19 June 2026

RE: **RESPONSE TO FURTHER ISSUES NOTICE FOR PROPOSED WAREHOUSE AND INDOOR SPORT / RECREATION (EXTENSION BEING A NEW CAR PARK) ON LAND AT 260 MUSGRAVE ROAD, COOPERS PLAINS Q 4108 (COUNCIL FILE REFERENCE A006876448)**

Figure 1: Aerial Imagery of Corridor including development of the adjoining industrial premises to the west.

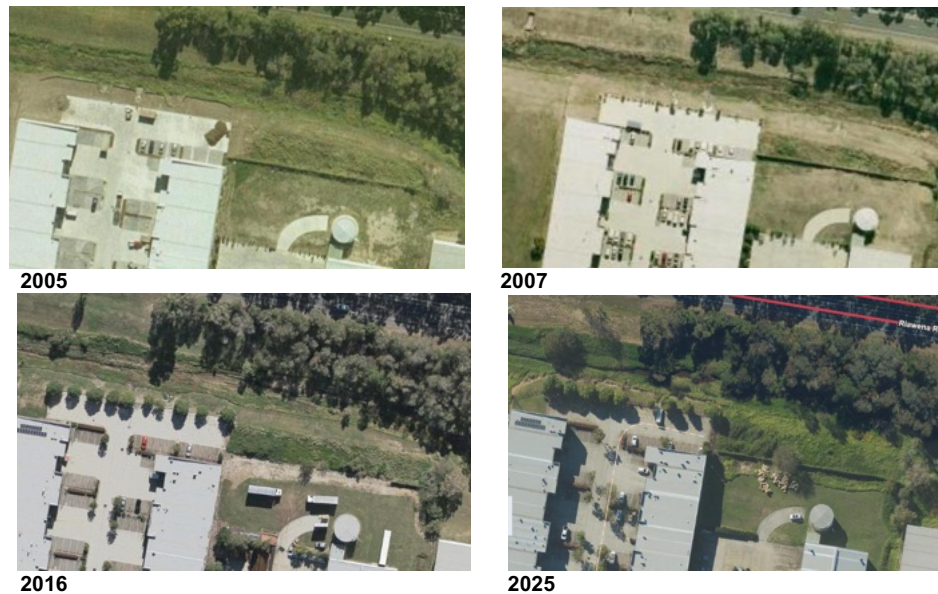
In reference to Council's request for RPEQ certification for compliance with PO1, PO6, PO7 and P10 of *Waterway corridors overlay code*, we wish to reiterate the previous representations in response to the information request as well as the original planning report whereby the extent

of works within the corridor will have no impact on the limited biodiversity values along the southern side of the corridor.

The aerial imagery in Figure 1 below clearly shows that the open grassed area has been devoid of any riparian / waterway vegetation which historically has been limited to the northern side of the centreline of the corridor.

The site photographs in Figure 2 show that the corridor is impacted by noxious weeds. It is intended that as part of the proposed works, the rehabilitation of the corridor will involve the removal of noxious weeds and the establishment of new vegetation on the southern side of the centreline. On this basis, compliance with PO6 of the *Waterway overlays code* is demonstrated in so far that the proposed works:

- Avoid fragmentation of the waterway;
- Will not require compensatory earthworks in accordance with the relevant planning scheme policy given all works are outside Creek / Waterway sub-categories 1, 2 and 3 of the Flood overlay;

- Maintain environmental connectivity along the waterway which to date has been limited to the northern side of the centreline;
- Will maintain natural flow of runoff and drainage whilst protecting the conveyance of water from upstream properties as well as the state controlled road corridor to the north;

- Do not involve new buildings within the waterway with the extent of works limited to open hardstand with new landscaping to the southern side of the centreline to establish riparian / waterway vegetation;

- Will be setback further from the centreline of the corridor compared to the established development on either side of the subject site; and
- Do not require dedication of land for recreation purposes as the land is not identified for trunk infrastructure (i.e. stormwater and open space) under the current infrastructure plan.

Whilst an ecological impact assessment would normally be provided, the extent of works is contained in an area completely devoid of any vegetation or evidence of fauna habitat given the primary function of the corridor is for the conveyance of rainwater and drainage. Consequently, a condition of development should include a rehabilitation of the corridor in conjunction with a landscape and site works plan to establish new waterway corridor vegetation

on the southern side of the centreline.

Figure 3: Carpark Location in BCC Flood overlay & Extent of Post-Development Flood Depth for 1% AEP.

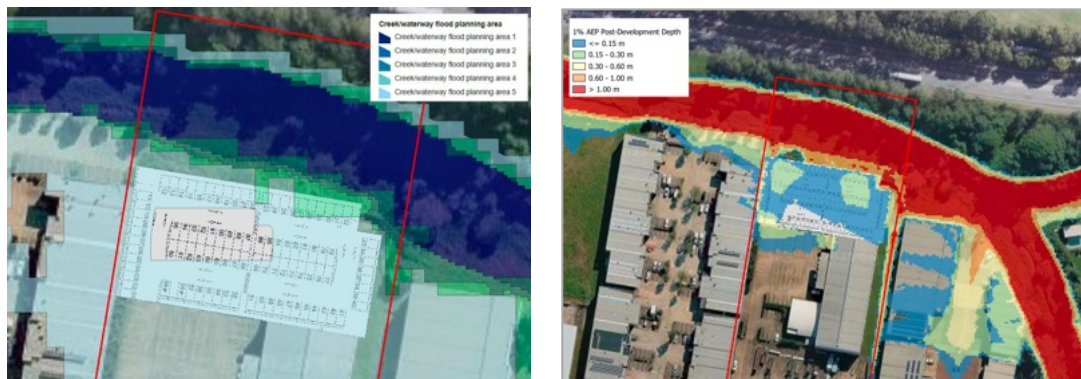
In reference to the depth of flooding in a Creek 1% AEP, as previously mentioned the peak height of any flooding across the rear of the proposed car park is no greater than 260mm with the majority of the car park being less than 150mm as highlighted in Figure 3 below.

During a 1% Annual Exceedance Probability flood event, the area will remain trafficable. Appropriate flood warning signage can be installed noting the minor flood impacts across the rear of the site and as such can be conditioned accordingly. Consequently the Hydraulic Impact Assessment prepared by Biome Water and Environmental Consulting demonstrates that the proposal complies with the *Flood overlay code* in so far that it:

- minimises the risk to people from flood hazard on the site;
- minimises flood damage to the development and contents of buildings up to the defined flood event; and
- provides suitable amenity.
